NO: CON - 098
DATE: July 2021

PRODUCT: XG4E – Flat Cable Connectors
TYPE: MODIFICATION – Change to Printing Method

XG4E Flat Cable Connectors - Change to Printing Method

XG4E Details of the Changes:

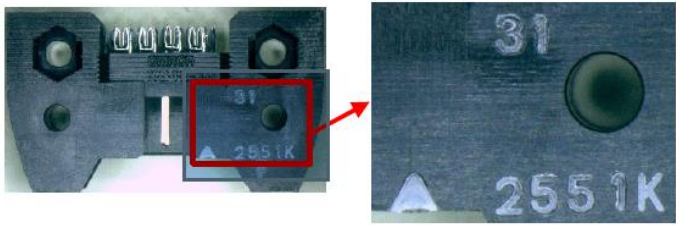
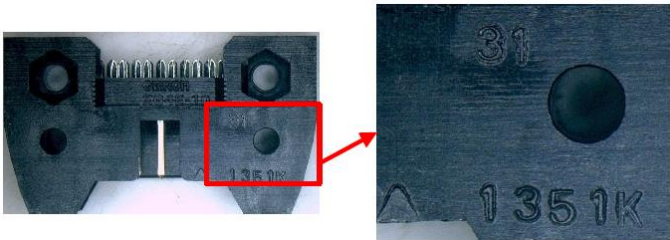
Before the change	After the change
Printing method: Heat Transfer printing Color of marking text: White 	Printing method: Heat Stamp Color of marking text: Black
